# **Joint Assessment of Cable Damage and Quantification of Effects from Fire (JACQUE-FIRE)**

## **Volume 3: Technical Resolution to Open Issues On Nuclear Power Plant Fire-Induced Circuit Failure**

Volume 3: Technical Resolution to Open Issues on  
Nuclear Power Plant Fire-Induced Circuit Failure

*Joint Assessment of Cable Damage and Quantification of Effects from Fire (JACQUE-FIRE), Volume 3: Technical Resolution to Open Issues on Nuclear Power Plant Fire-Induced Circuit Failure*, U.S. Nuclear Regulatory Commission, Office of Nuclear Regulatory Research (RES), Washington, DC, and Electric Power Research Institute (EPRI), Palo Alto, CA, NUREG/CR-7150 V3, BNL-NUREG-98204-2012 V3, and EPRI 3002009214, 2017.

5-3, Entire Page

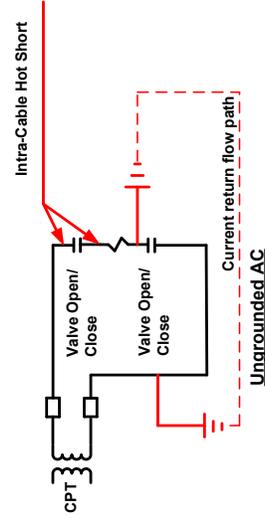
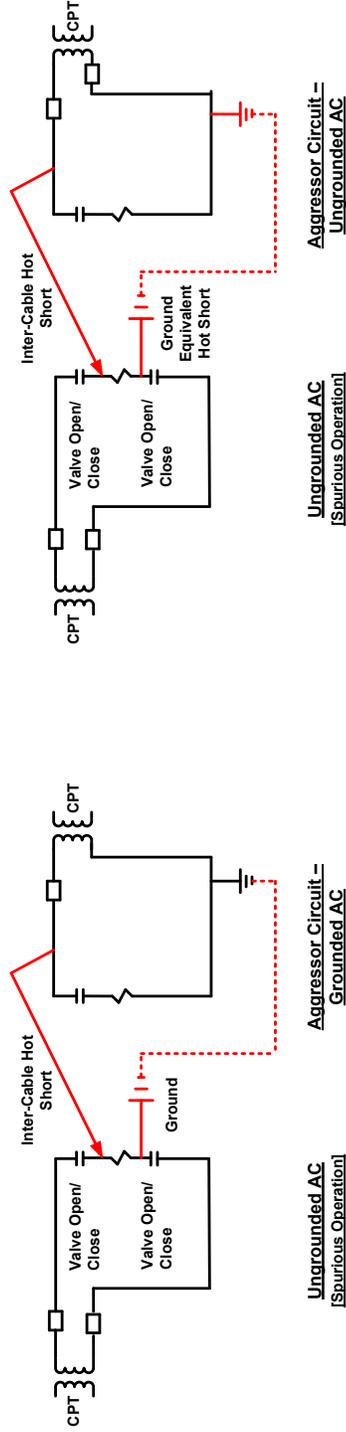
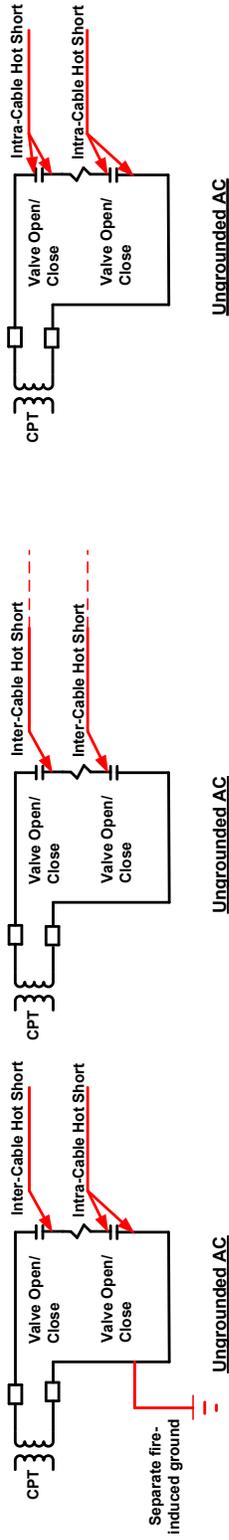
Entire page is a duplicate of Page 5-2 and should be deleted.

**Figure B-2 Double Break Ungrounded DC Schematics**

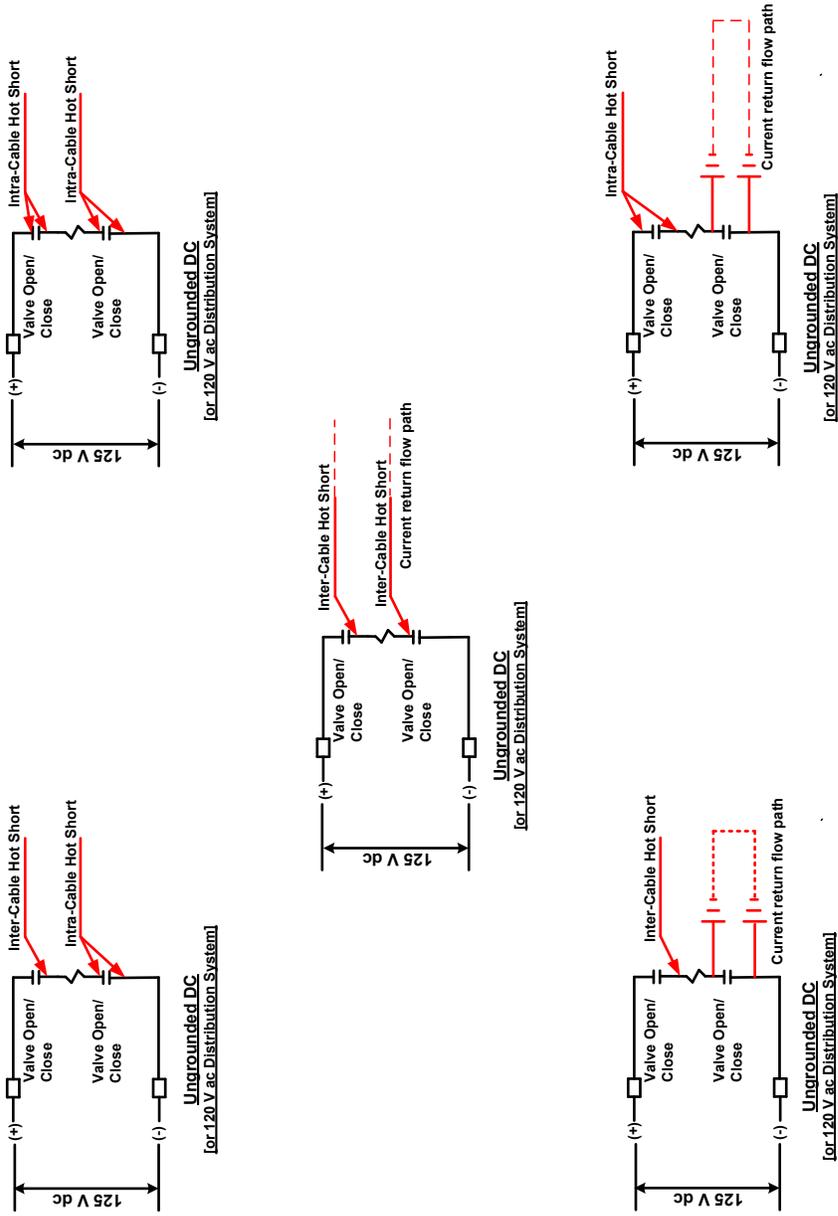
1. SECTION 3 of the PIRT Report: PIRT PANEL EVALUATION OF CONTROL CIRCUITS – Figure 3-8 and Figure 3-9.
2. APPENDIX C of the PIRT Report: CONTROL CIRCUIT CONFIGURATIONS FOR SINGLE AND DOUBLE BREAK DESIGNS – Case 1 through Case 8.

**Note:** The examples in this figure show one proper polarity alignment that could result in a spurious operation. Refer to the section of this NUREG/CR Report that describes Proper Polarity to understand those additional proper polarity alignments that may also apply.

**Figure C-1 Ungrounded AC from a CPT – Double Break Design**

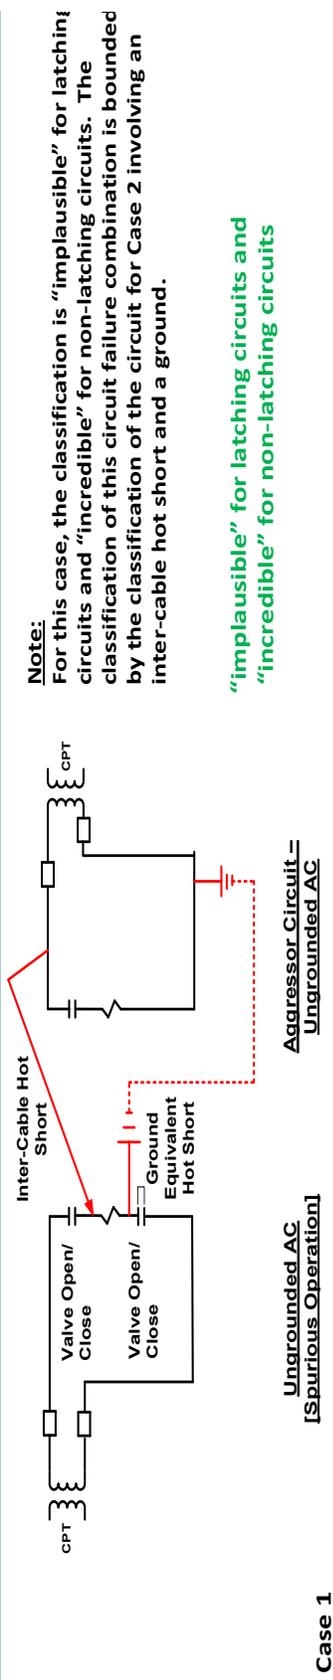
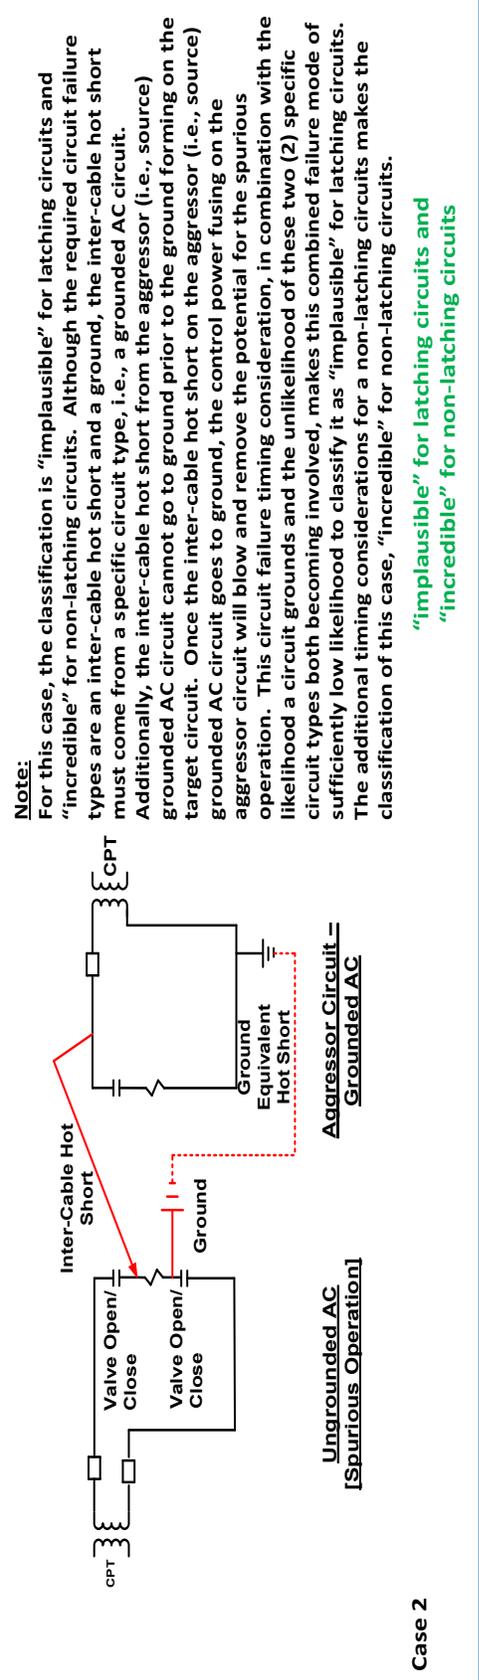
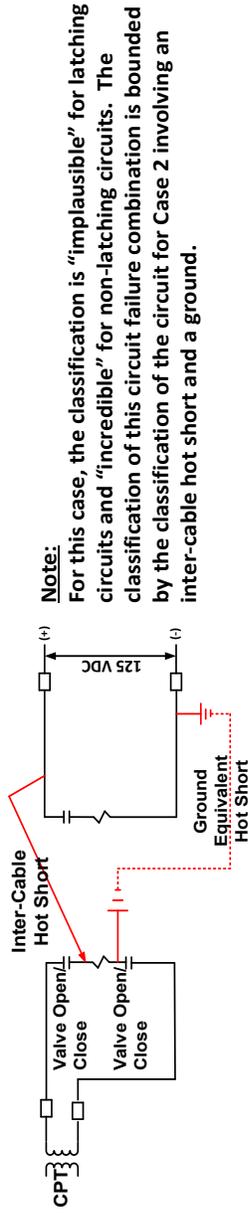
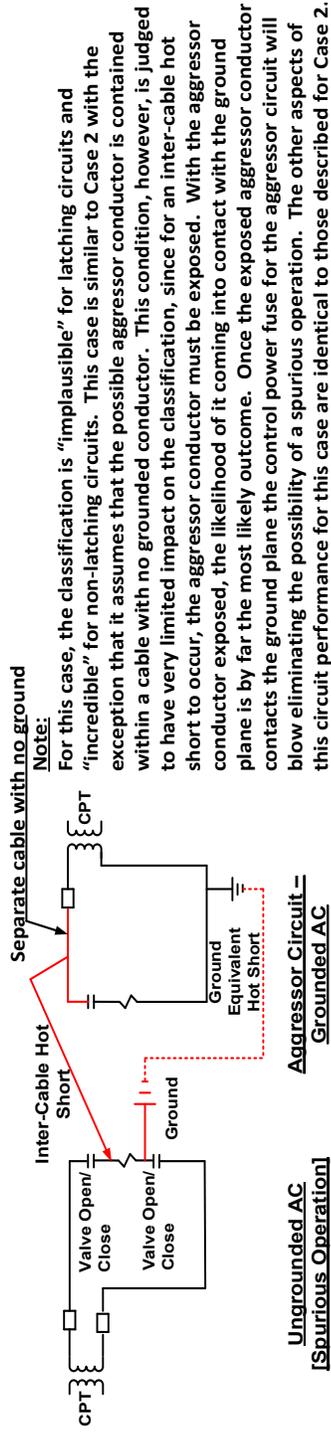
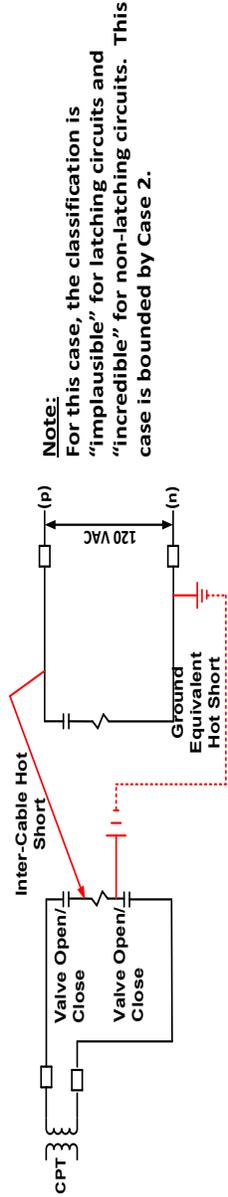
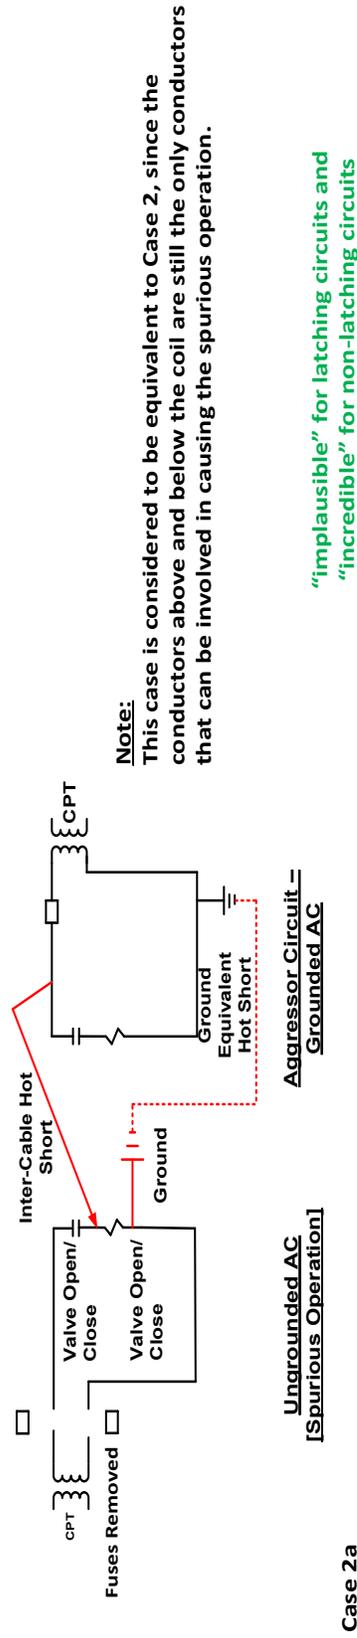
**Note:**  
For this case, the classification is “implausible” for latching circuits and “incredible” for non-latching circuits. The classification of this circuit failure combination is bounded by the classification of the circuit for Case 2 involving an inter-cable hot short and a ground.

“implausible” for latching circuits and  
“incredible” for non-latching circuits

**Figure C-3 Ungrounded DC – Double Break Design**

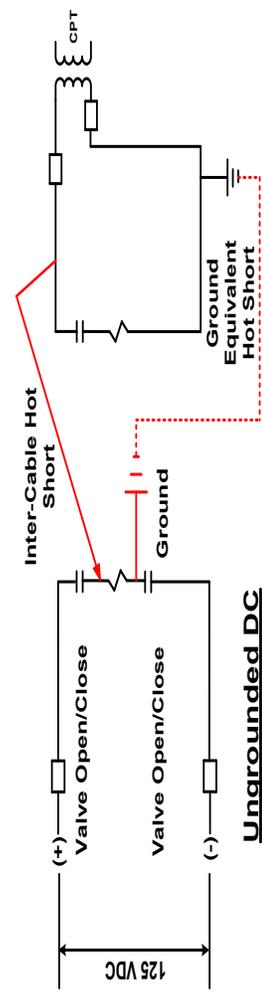
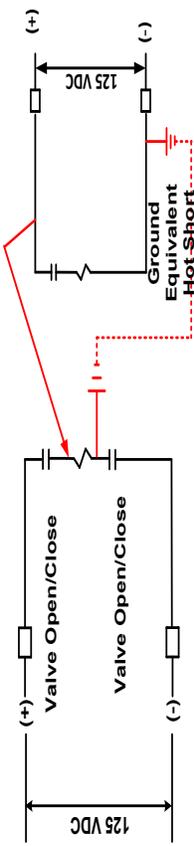
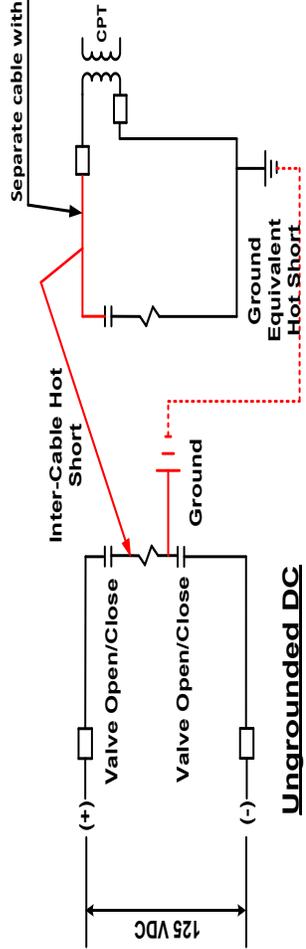
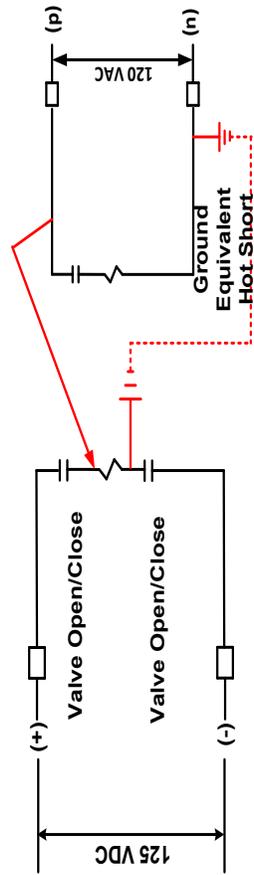
**Note:**  
For this case, the classification is “implausible” for latching circuits and “incredible” for non-latching circuits. The classification of this circuit failure combination is bounded by the classification of the circuit for Case 7 involving an inter-cable hot short and a ground.

“implausible” for latching circuits and “incredible” for non-latching circuits

Figure C-4 Ungrounded DC – Pseudo-Double Break Design

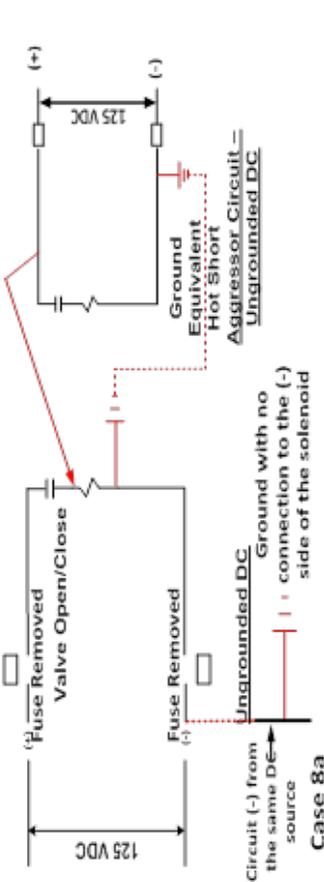
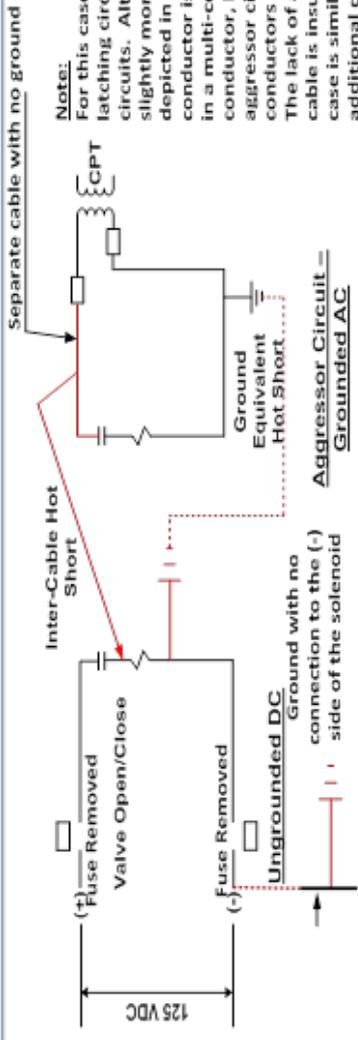
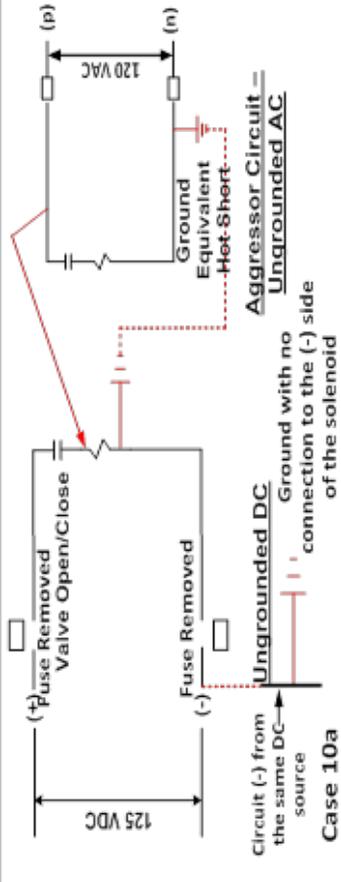
**Note:**  
For this case, the classification is "implausible" for latching circuits and "incredible" for non-latching circuits. The classification of this circuit failure combination is considered to be bounded by the classification of the circuit for Case 7a involving an inter-cable hot short and a ground.

**Note:**  
For this case, the classification is "implausible" for latching circuits and "incredible" for non-latching circuits. Although this case is considered to be slightly more likely than the failure modes depicted in Case 7a, since the possible aggressor conductor is in either a single conductor cable or in a multi-conductor cable without any grounded conductor, likelihood of a blown fuse on the aggressor circuit due to exposing of the (+) conductors would still be expected to dominate. The lack of a ground conductor in the aggressor cable is insufficient to alter the classification. This case is similar to Case 8. Refer to Case 8 for additional details.

**"implausible" for latching circuits and "incredible" for non-latching circuits**

**"implausible" for latching circuits and "incredible" for non-latching circuits**

Figure C-5 Ungrounded AC Distributed – Double Break Design

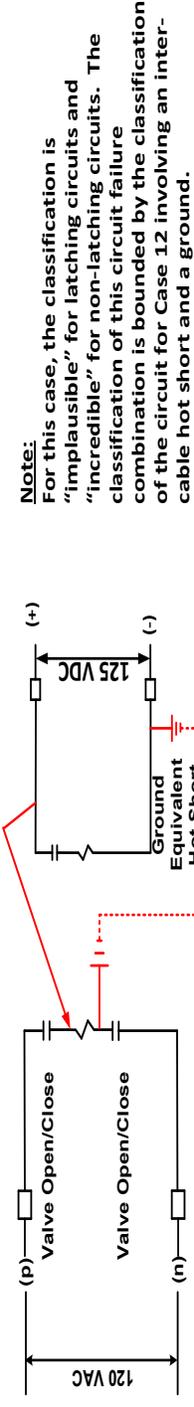
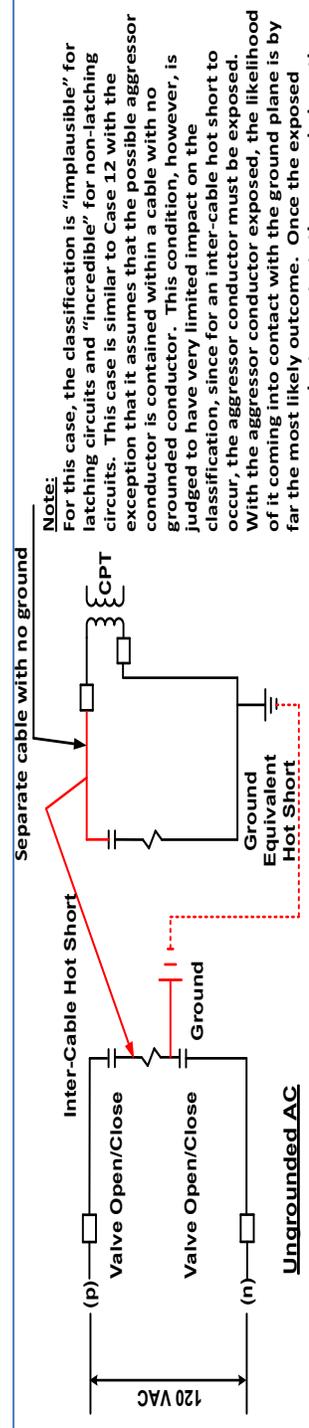
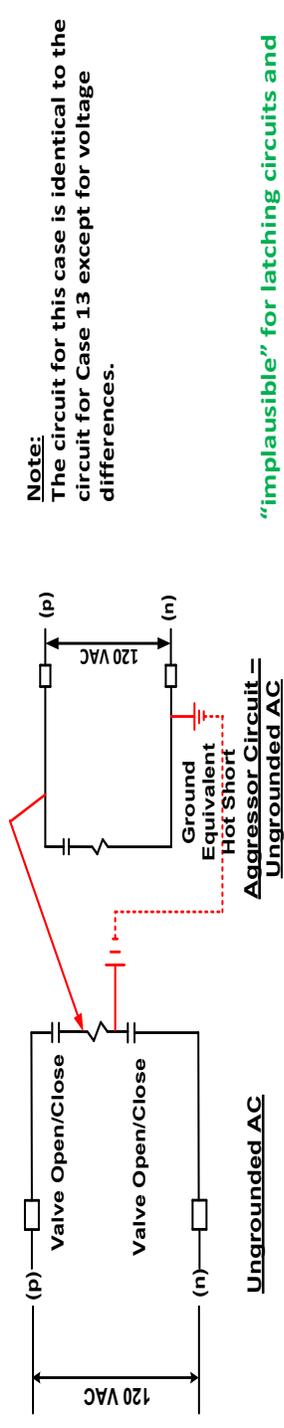
**Note:**  
For this case, the classification is “implausible” for latching circuits and “incredible” for non-latching circuits. The combination of this circuit failure classification is bounded by the classification of the circuit for Case 12 involving an inter-cable hot short and a ground.

“implausible” for latching circuits and “incredible” for non-latching circuits

**Figure C-6 Ungrounded AC Distributed – Pseudo-Double Break Design**

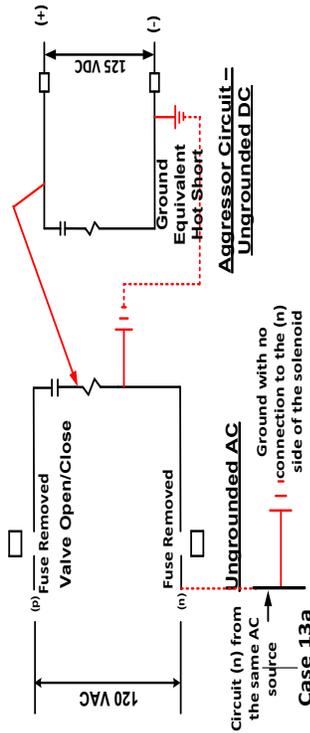
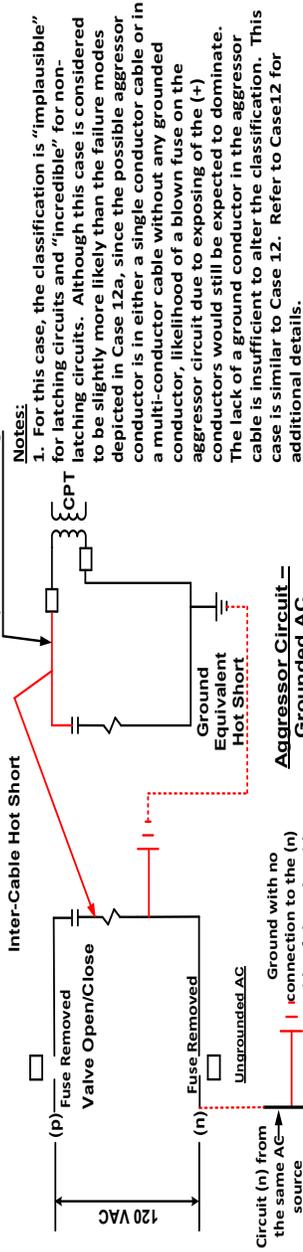
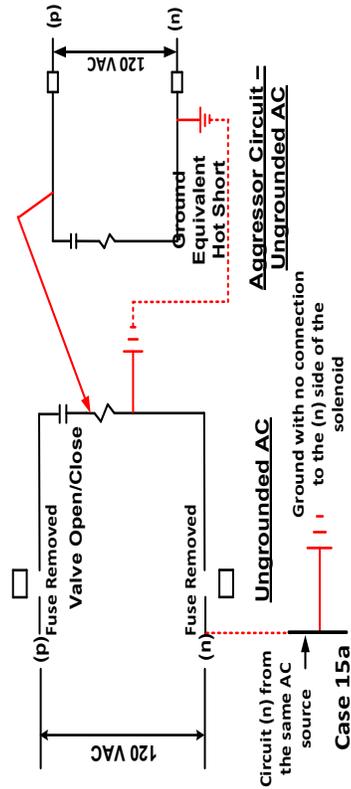
**Note:**  
For this case, the classification is “implausible” for latching circuits and “incredible” for non-latching circuits. The classification of this circuit failure combination is bounded by the classification of the circuit for Case 12 involving an inter-cable hot short and a ground.

**Note:**  
1. For this case, the classification is “implausible” for latching circuits and “incredible” for non-latching circuits. Although this case is considered to be slightly more likely than the failure modes depicted in Case 12a, since the possible aggressor conductor is in either a single conductor cable or in a multi-conductor cable without any grounded conductor, likelihood of a blown fuse on the aggressor circuit due to exposing of the (+) conductors would still be expected to dominate. The lack of a ground conductor in the aggressor cable is insufficient to alter the classification. This case is similar to Case 12. Refer to Case 12 for additional details.
